ADDENDUM NO. 2

Elm Road Elementary School – Interior Improvements

Penn-Harris-Madison School Corporation  
Mishawaka, Indiana

Project No. 223211.00

A0.01

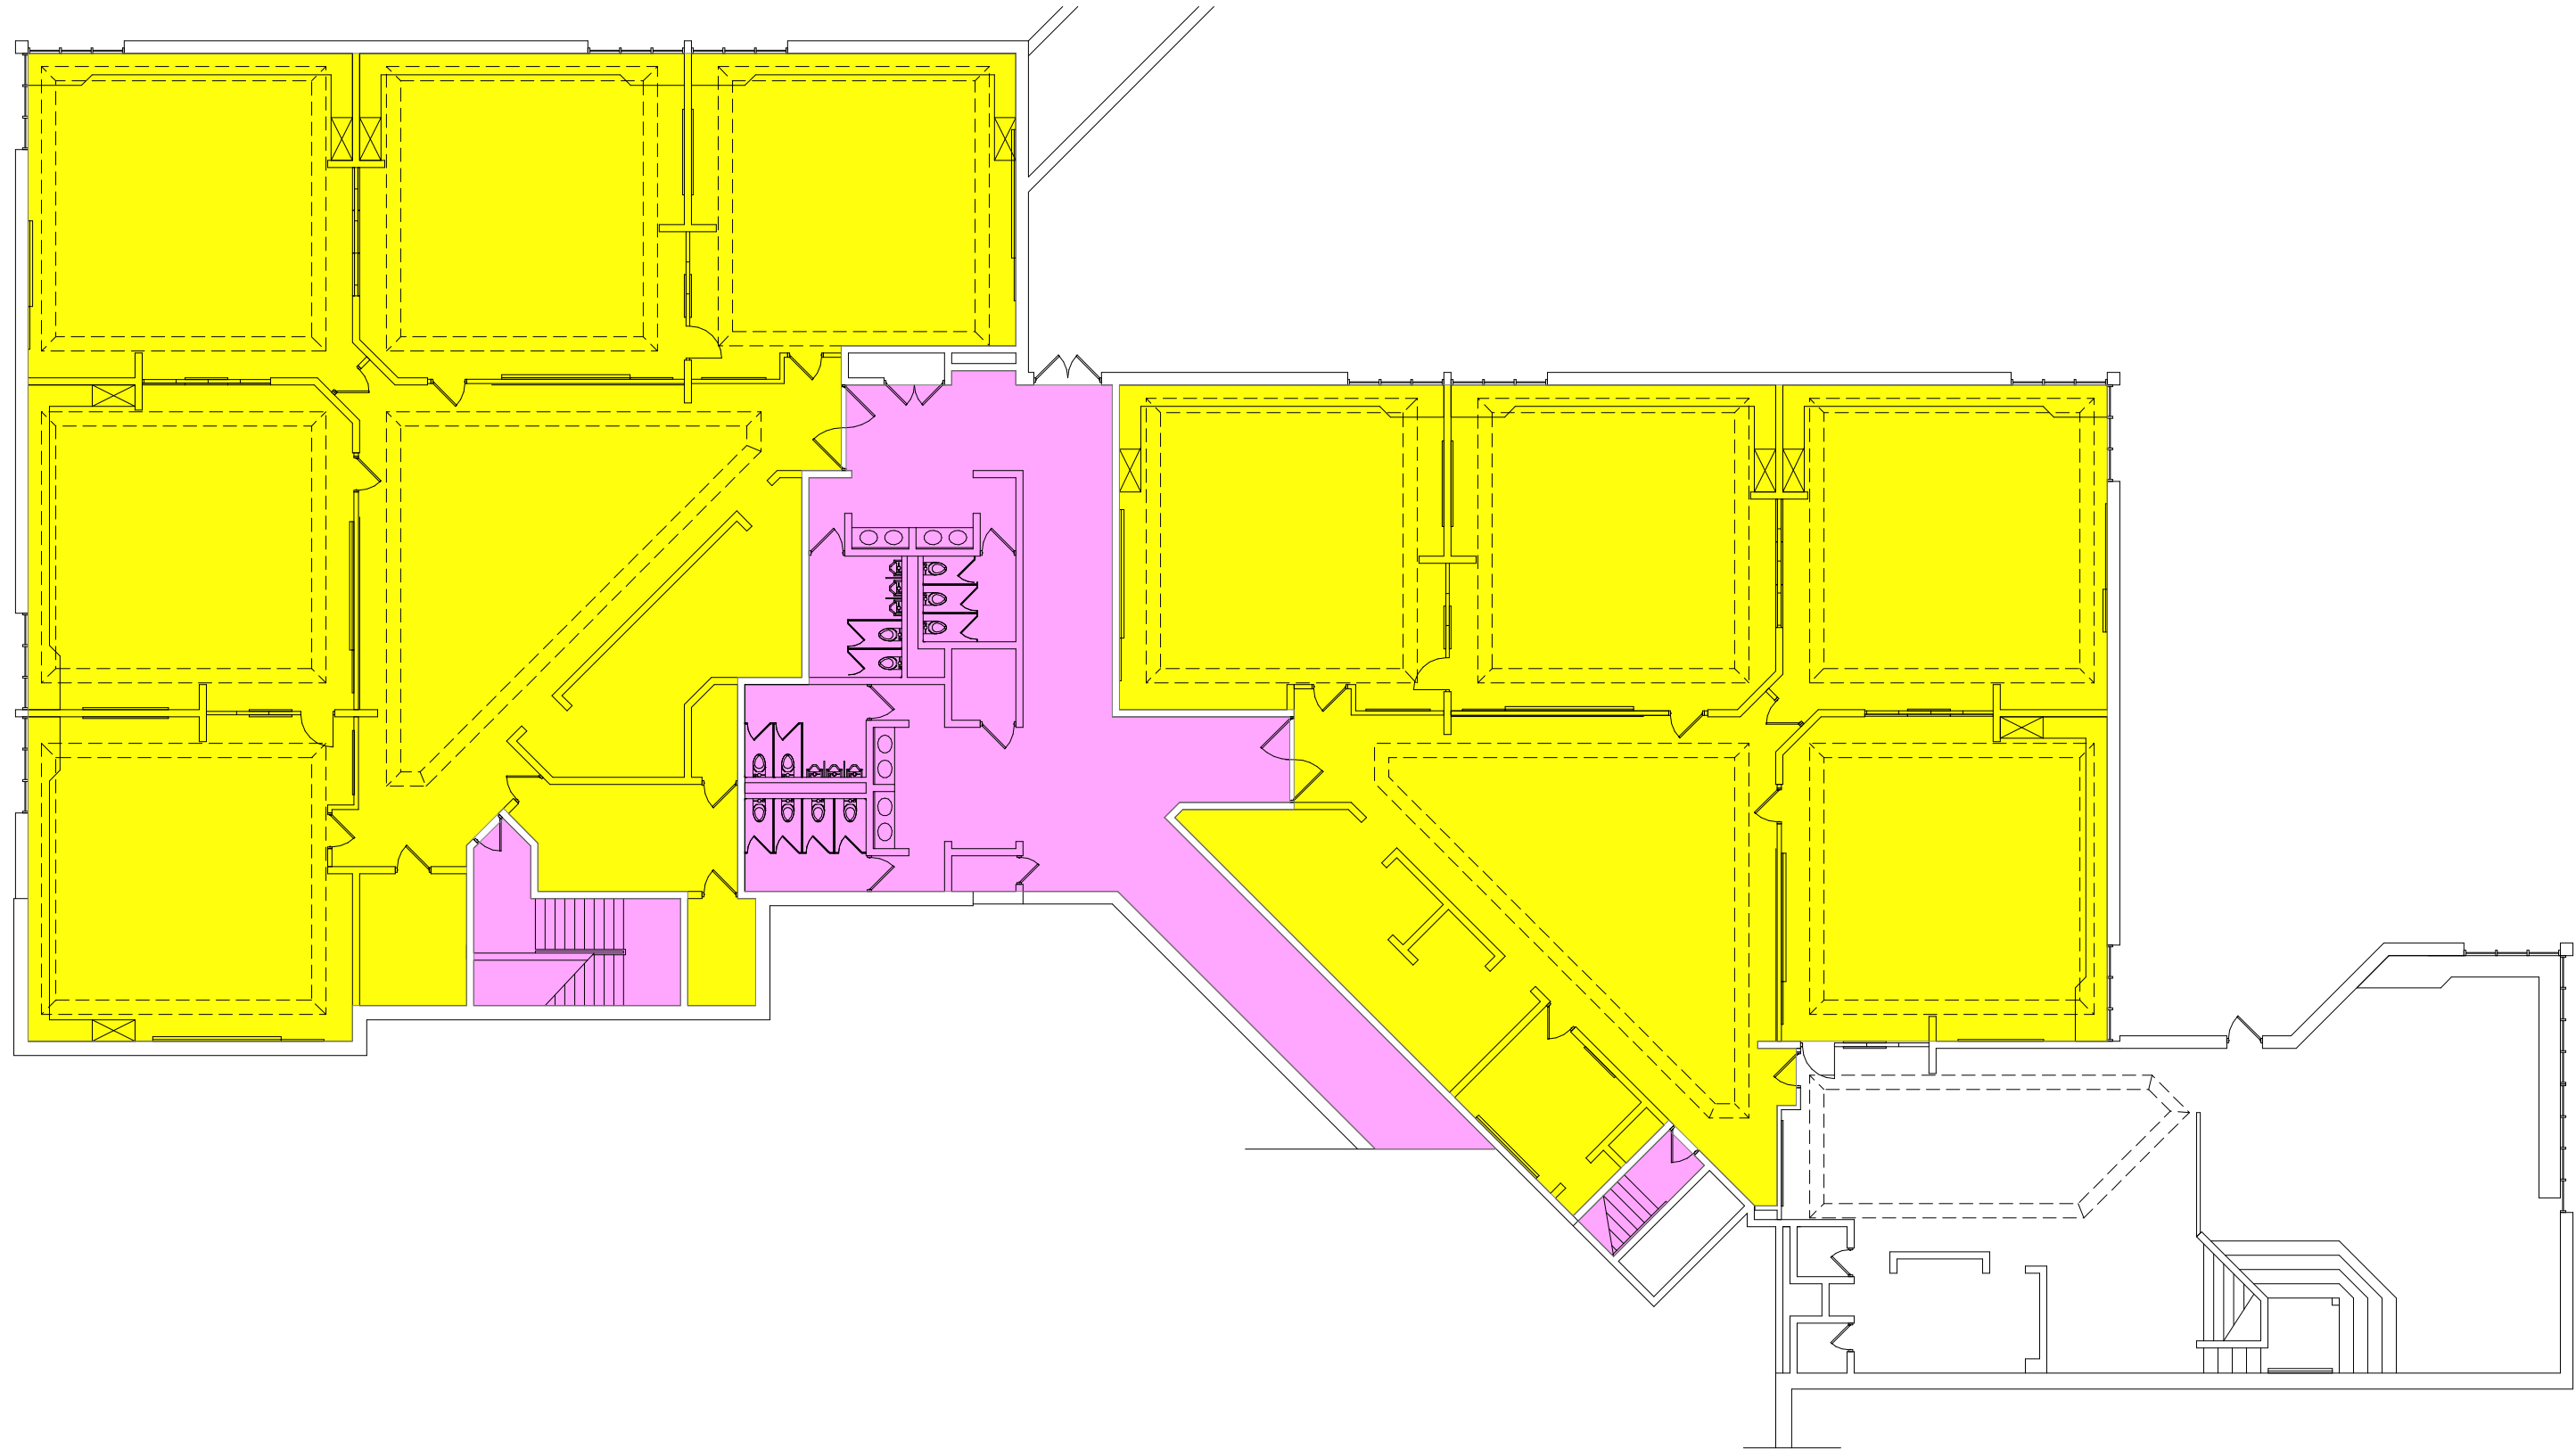
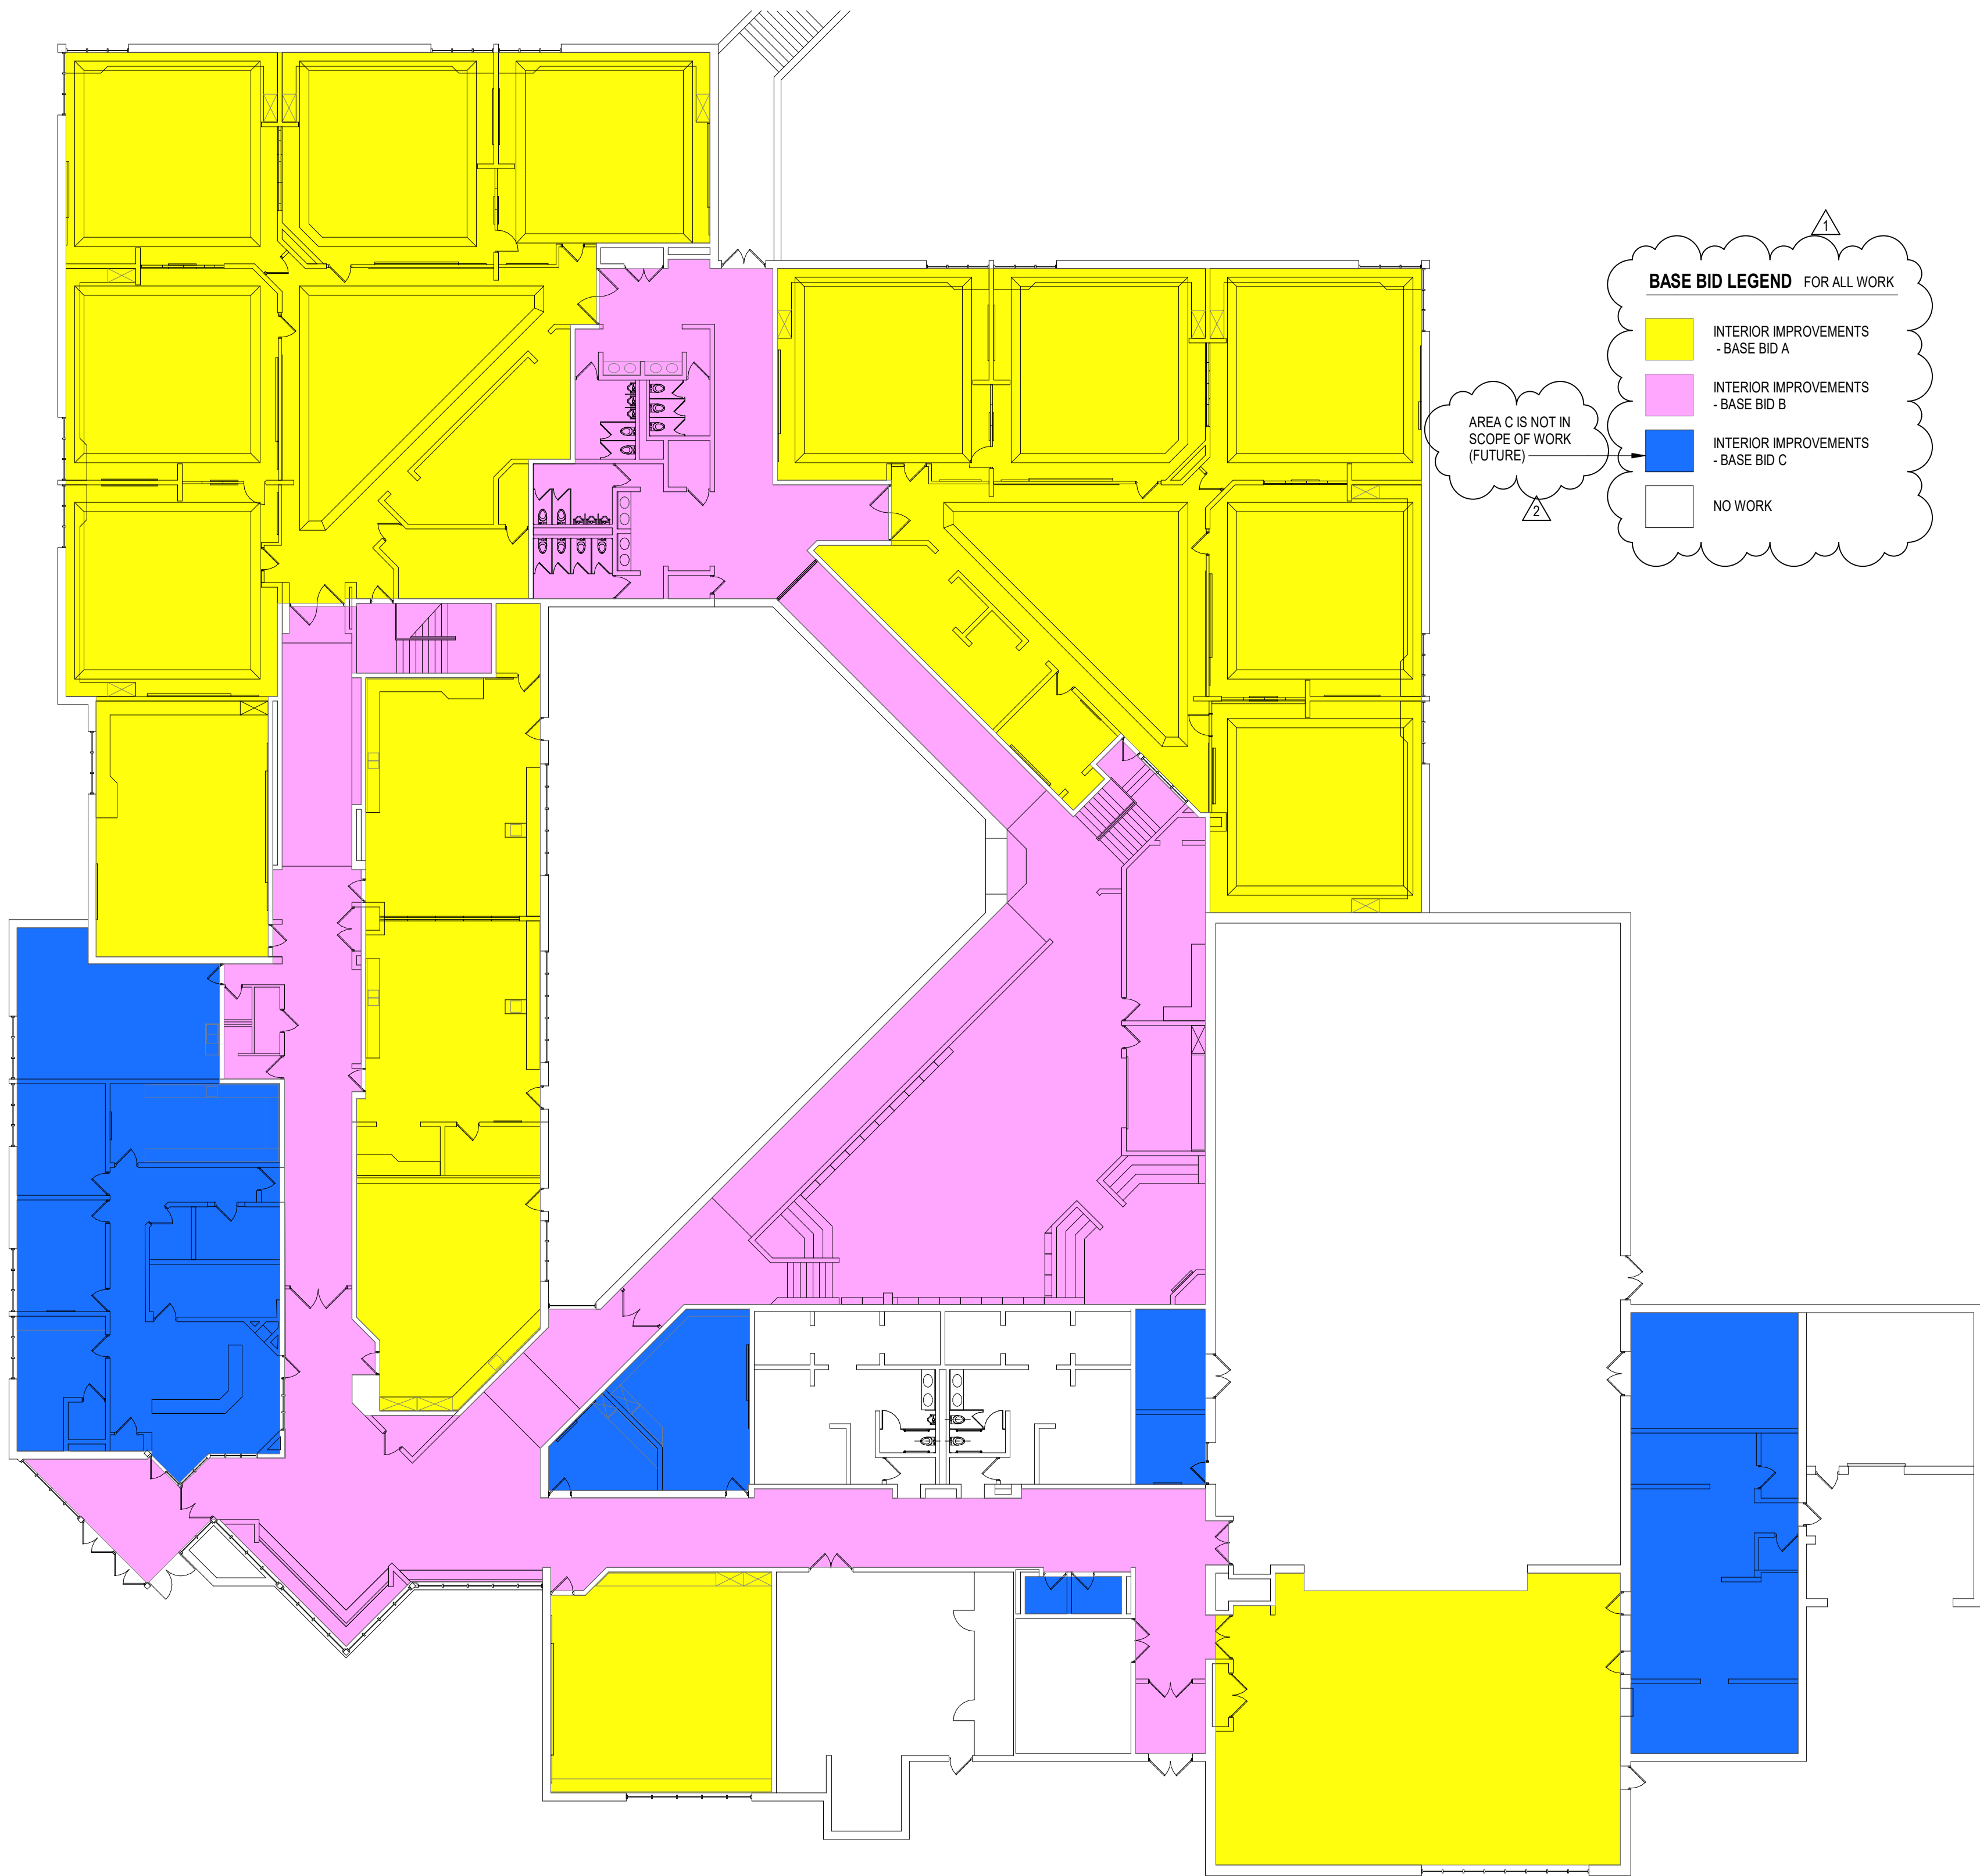
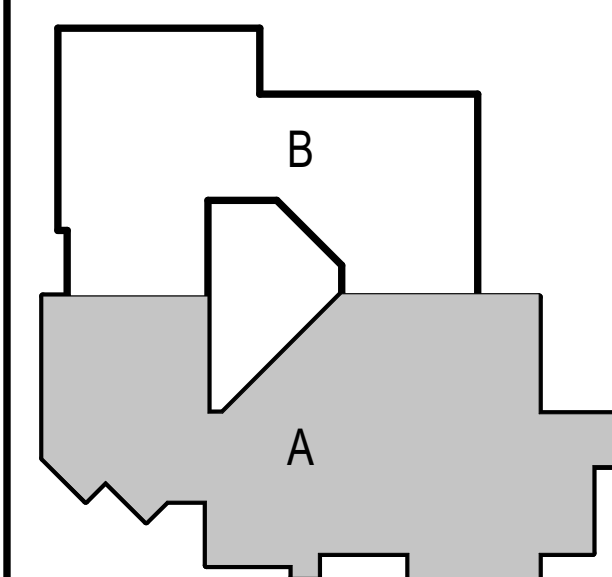
1. Is the intent of PHM to award the project to one contractor for Base Bids A and B.
2. The area identified as C (identified as Blue on Drawing A0.1) will be future.
